Addendum #4

RFP #2020-1222

GENERAL CONTRACTOR FOR THE WALTER I. M. HODGE DEVELOPMENT
ST. CROIX, U. S. VIRGIN ISLANDS

ADDENDUM #4

GROUND FLOOR PLAN - BLDG. TYPE E & E-1

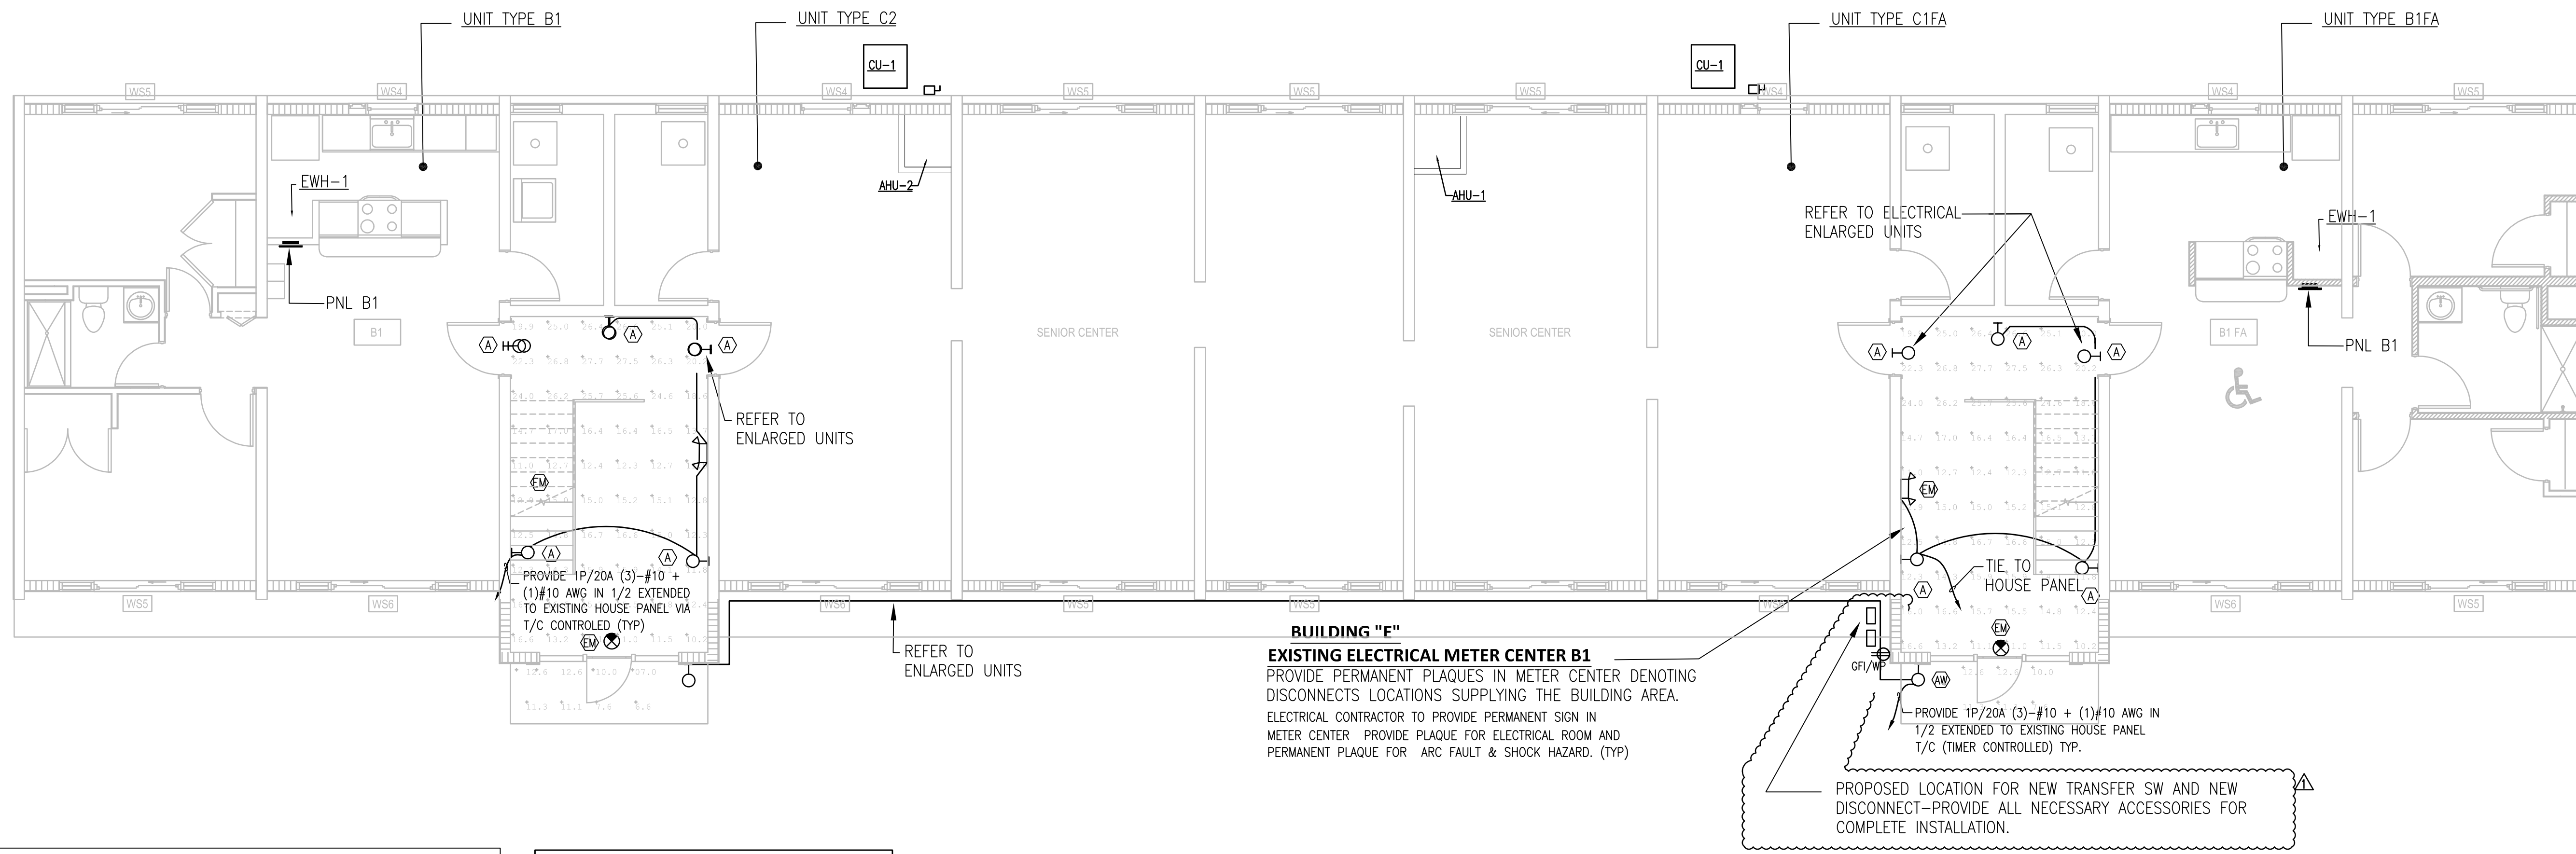
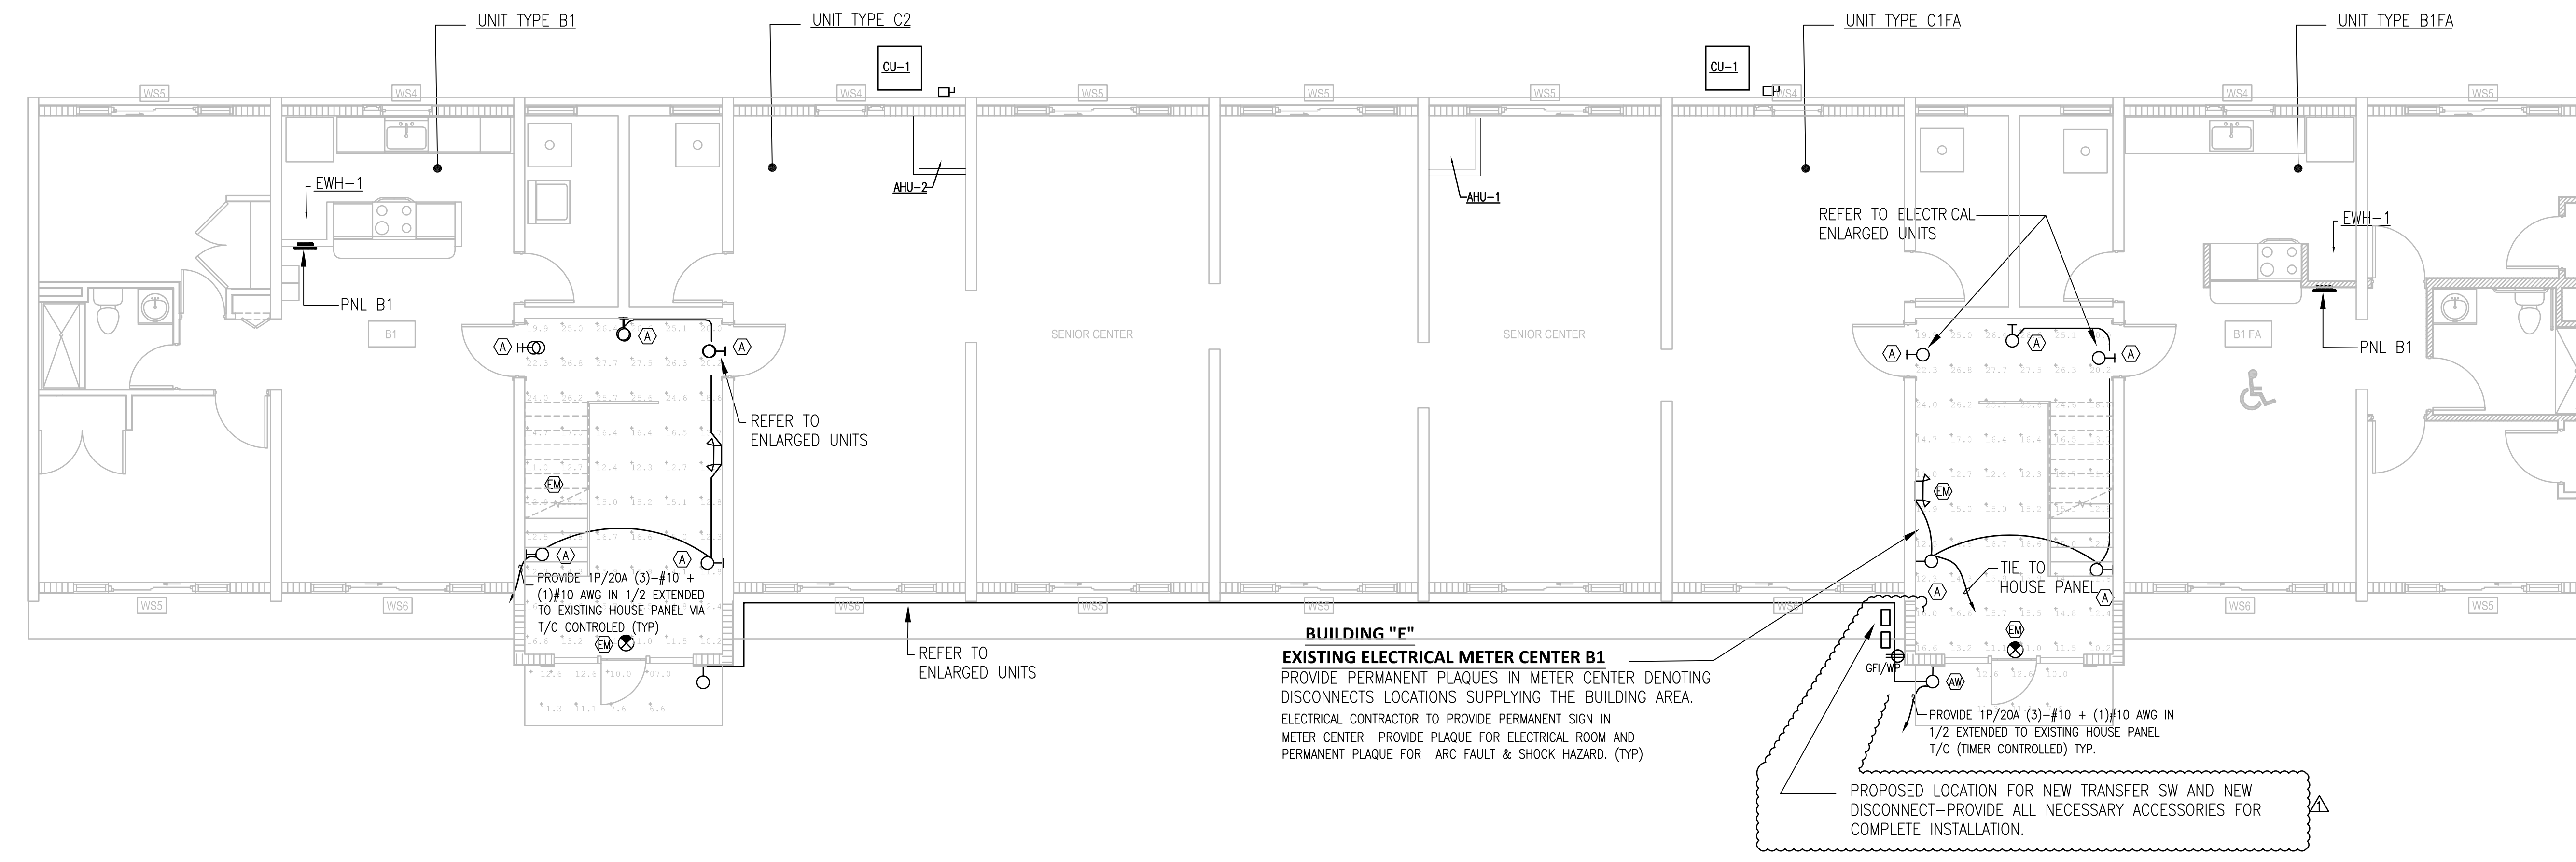
“There are no drawings of "building type E1" 2nd and 3rd floor for architectural, plumbing & electrical demolition, and its electrical proposed plan is also missing. But according to schedule on sheet A-0.02, 2nd and 3rd floor proposed Plan of building type E-1 is exactly the same as building type E. We are proceeding according to "type E 2nd and 3rd Floor." Can you please verify if any changes are required for building type E1.”

Clarification: E1 is only applicable to Building #12 for senior center layout at ground floor. 2nd and 3rd levels are typical layout for Building E

EXISTING TYPICAL POWER RISER DIAGRAM

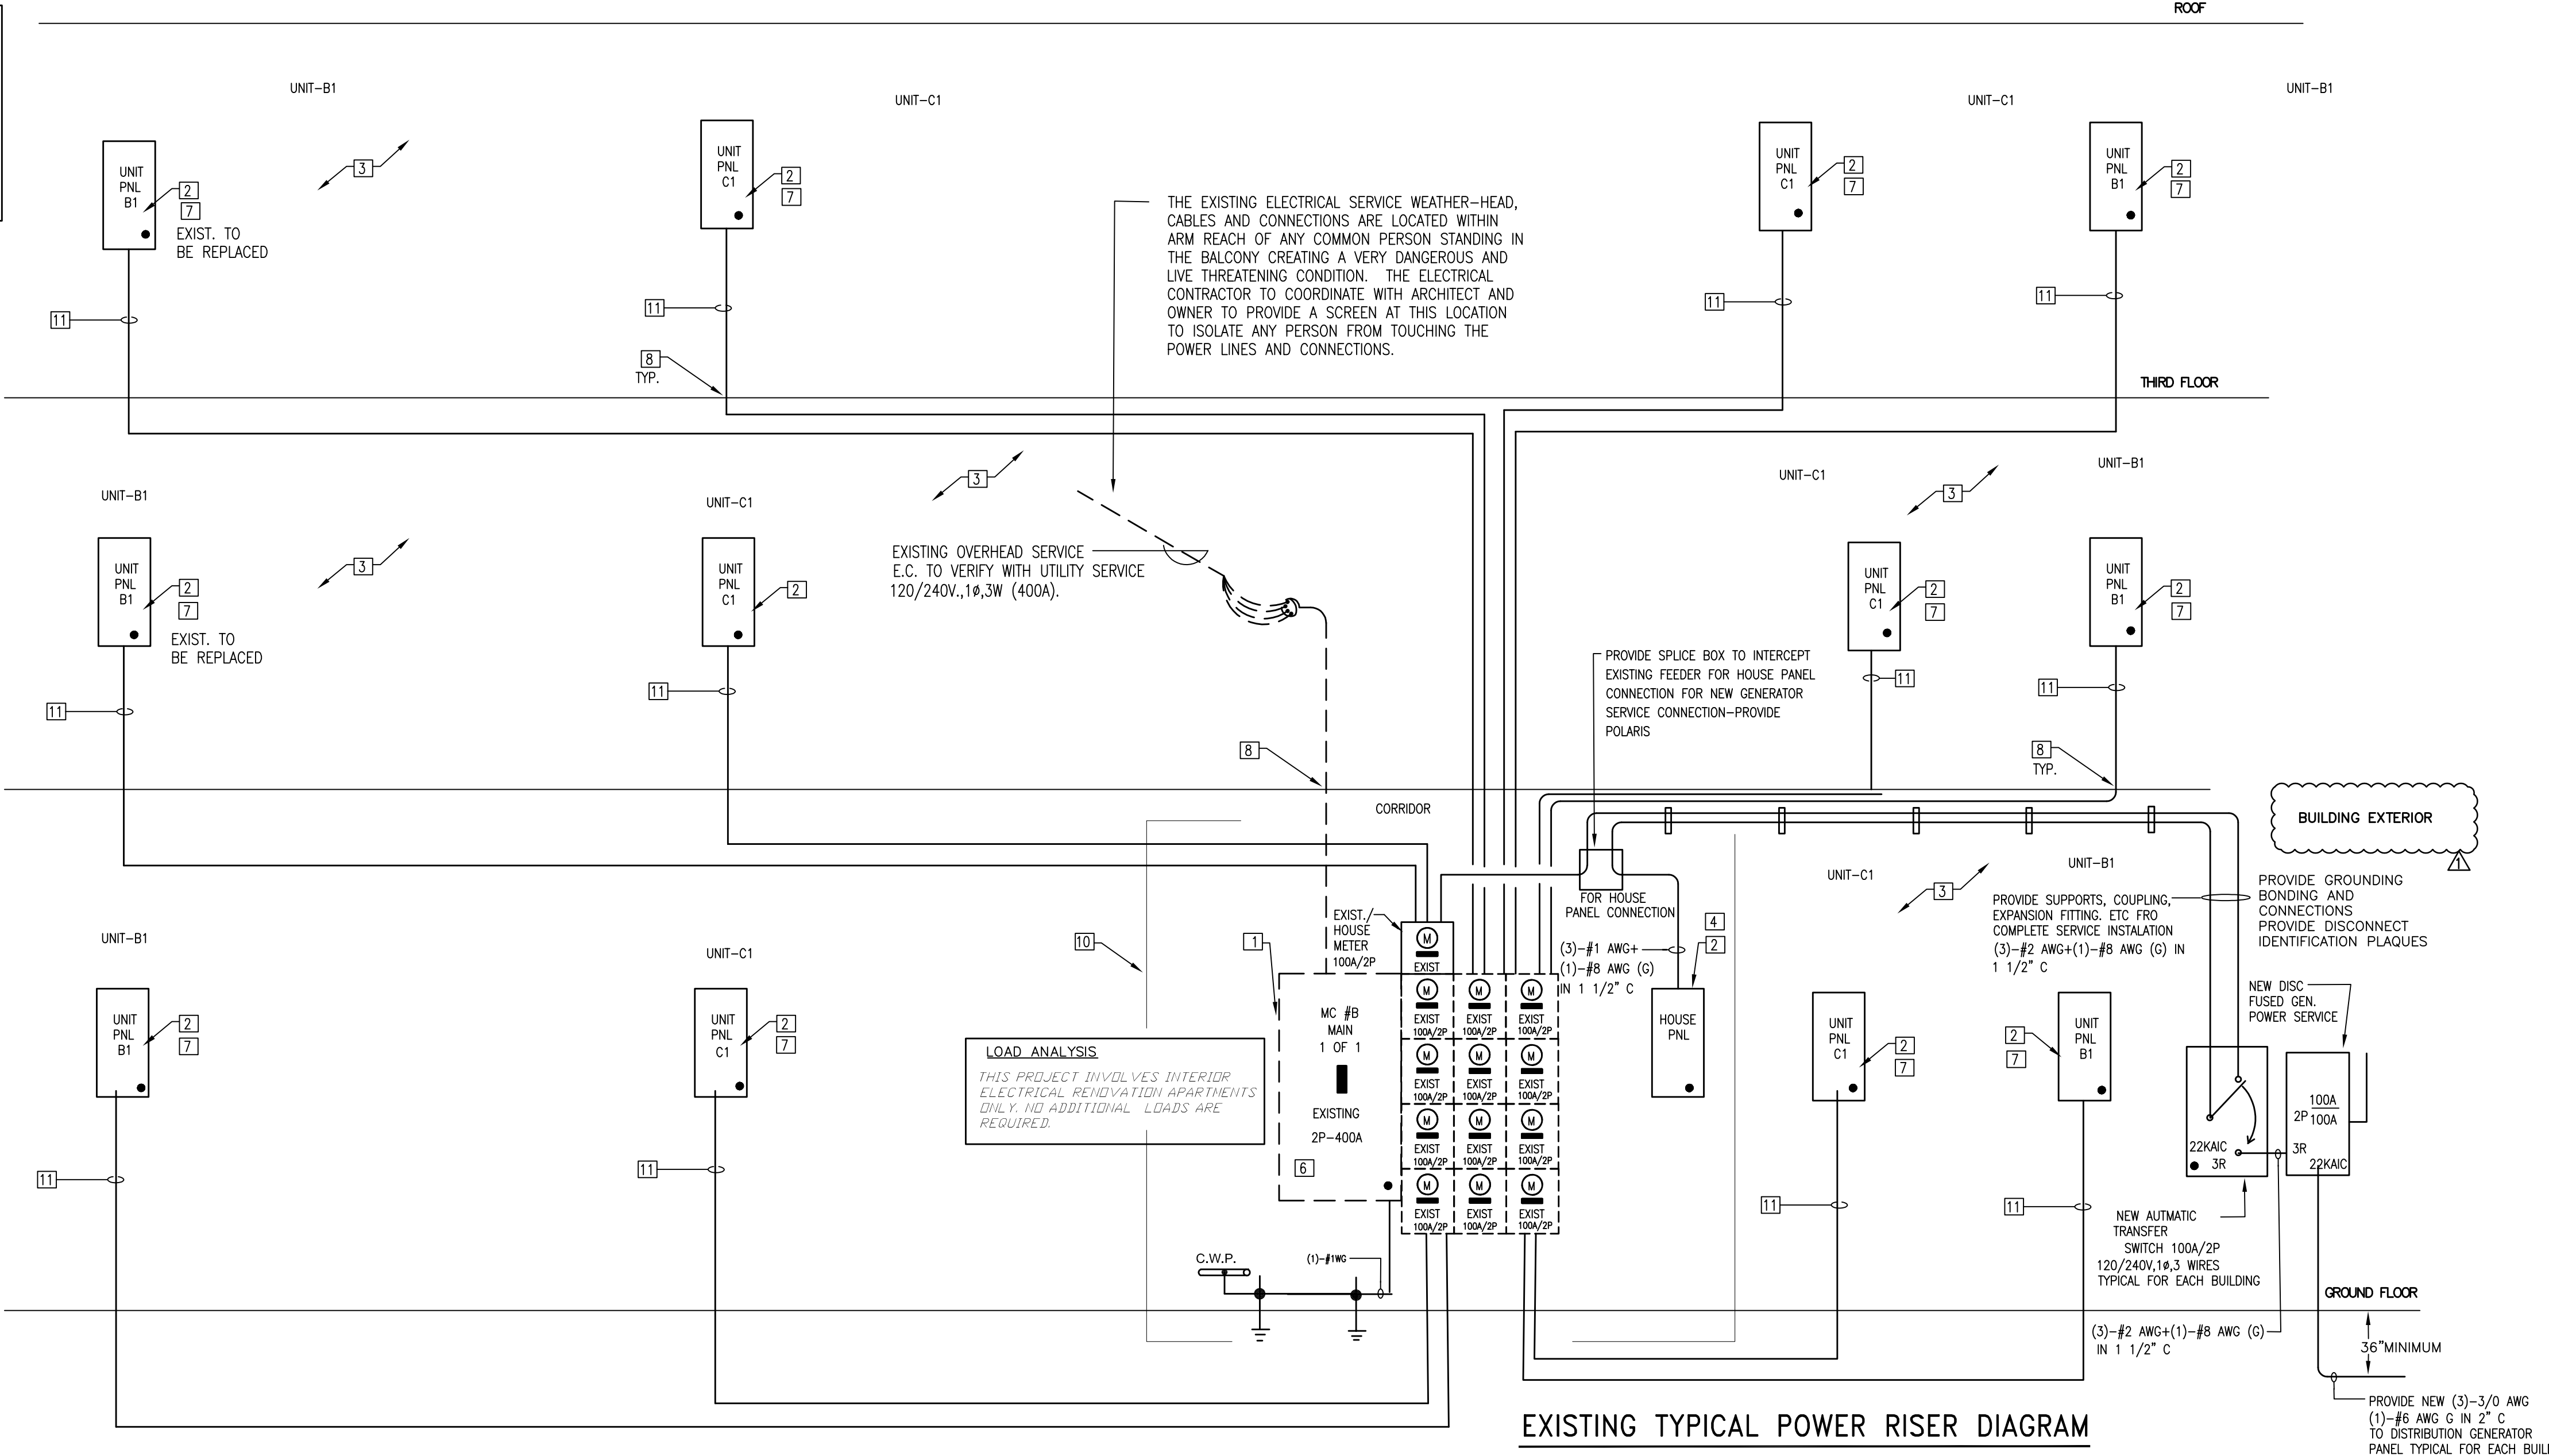
“The same issue is faced in the Power riser diagram on sheet E-3.04, Conduits are shown but no detail is given on site plan or any other Plan.”

Clarification: Routing of conduit to be field coordinated. The exact conduit quantity is shown on E-1.00A. Proposed location of transfer switch has been shown on building ground floor plans.
